SIB 34 04 24

RECALL 24V-697: INTEGRATED BRAKE SERVOMOTOR  
2025-10-31

This Service Information Bulletin (Revision 12) replaces SI B34 04 24 **dated August 2025**.

- Correction updated with new part numbers
- Parts Information updated

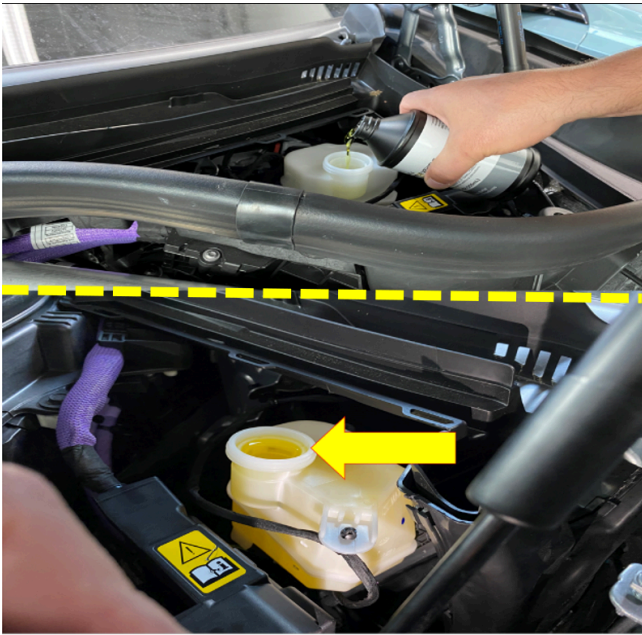
If a vehicle is programmed to I-level ...24-11-530 or higher BEFORE replacement of the IB, then the vehicle will need to be cycled to a “Driving” state and back to a “Residing” state **BEFORE** the IB is replaced. This will trigger the mileage sync with the new software. If this step is **NOT** performed before IB replacement, the mileage value may be inaccurate after IB replacement.
